ROCKWELL VILLAGE
A
PLANNED UNIT DEVELOPMENT
PUD / POADP
SAN ANTONIO, TEXAS

POADP # 645

Re: Rockwell Village POADP

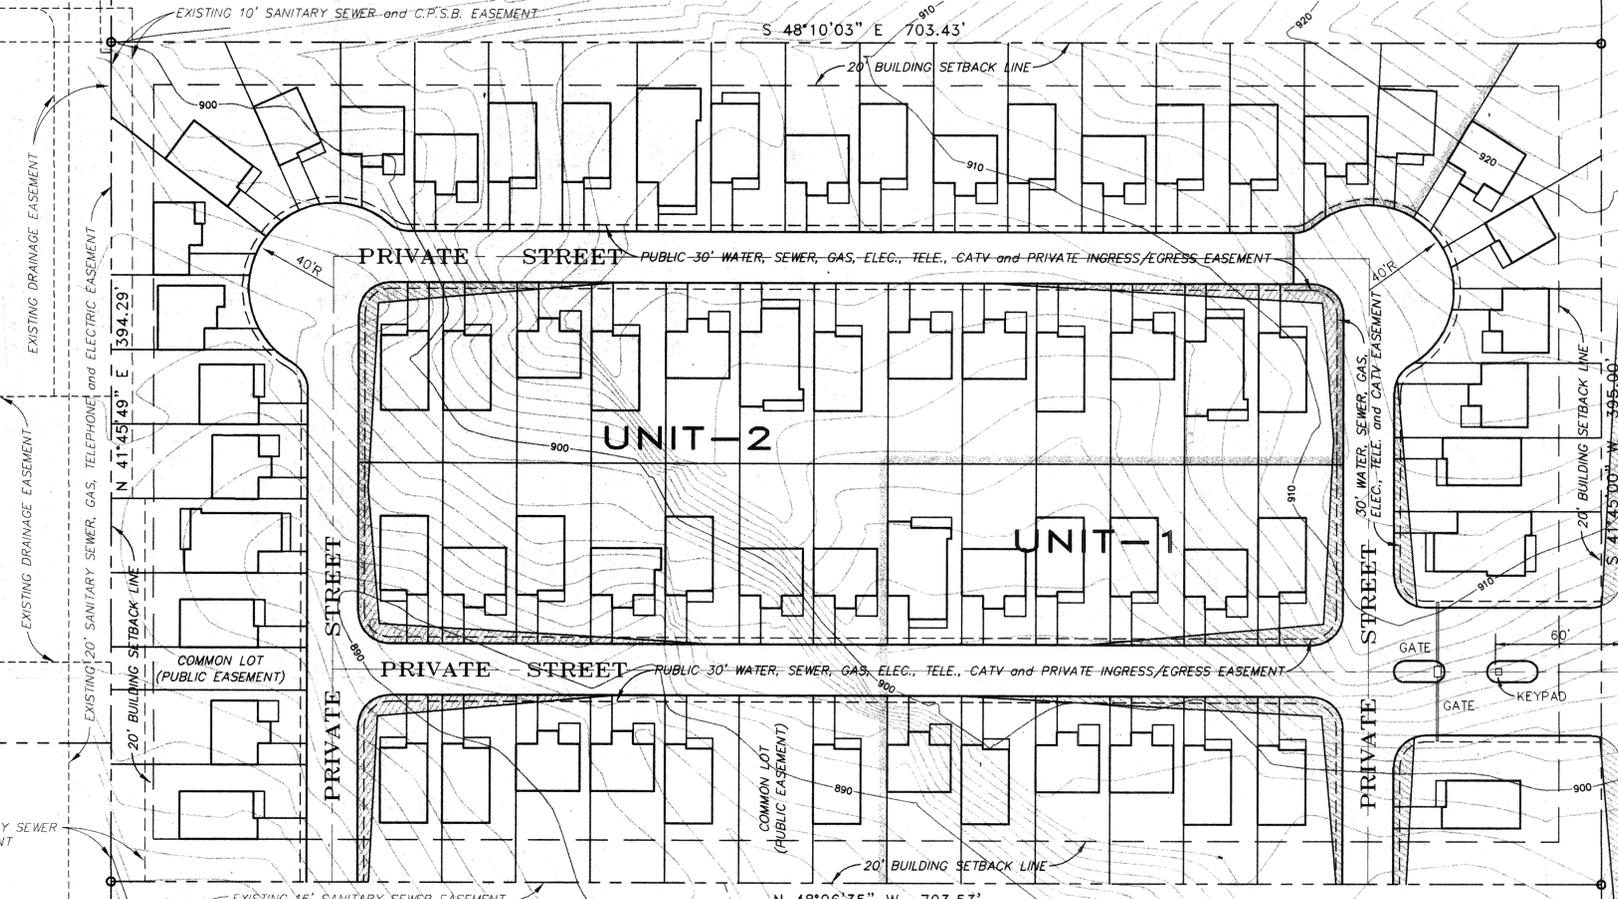
The City Staff Development Review Committee has reviewed Rockwell Village Preliminary Overall Area Development Plan # 645. Please find enclosed a signed copy for your files. Although your plan was accepted, please note the following:

- Based on the topography, a Flood Plain Study and drainage review will probably be required during the platting process.
- In consideration of public safety and convenience, excessive grades by reason of topography should be avoided in street layouts and arrangements.

- Access and R.O.W. issues along State facilities will need to be resolved with the Texas Department of Transportation (TXDOT). For information about these requirements you can contact TXDOT at 615-5814.

- This development will need to comply with tree preservation ordinance #85262. For information about these requirements you can contact Building Inspections at 207-7102.

- It will be expected that you will plat all of the property depicted in your POADP, to include: floodpains, drainage areas and open space.
- I would encourage you to work closely with the school district, so that they can plan accordingly.

- Public Works indicated that a TIA will not be required at this time due to the number of lots (77). However, a TIA may be required with future development adjacent to this site.
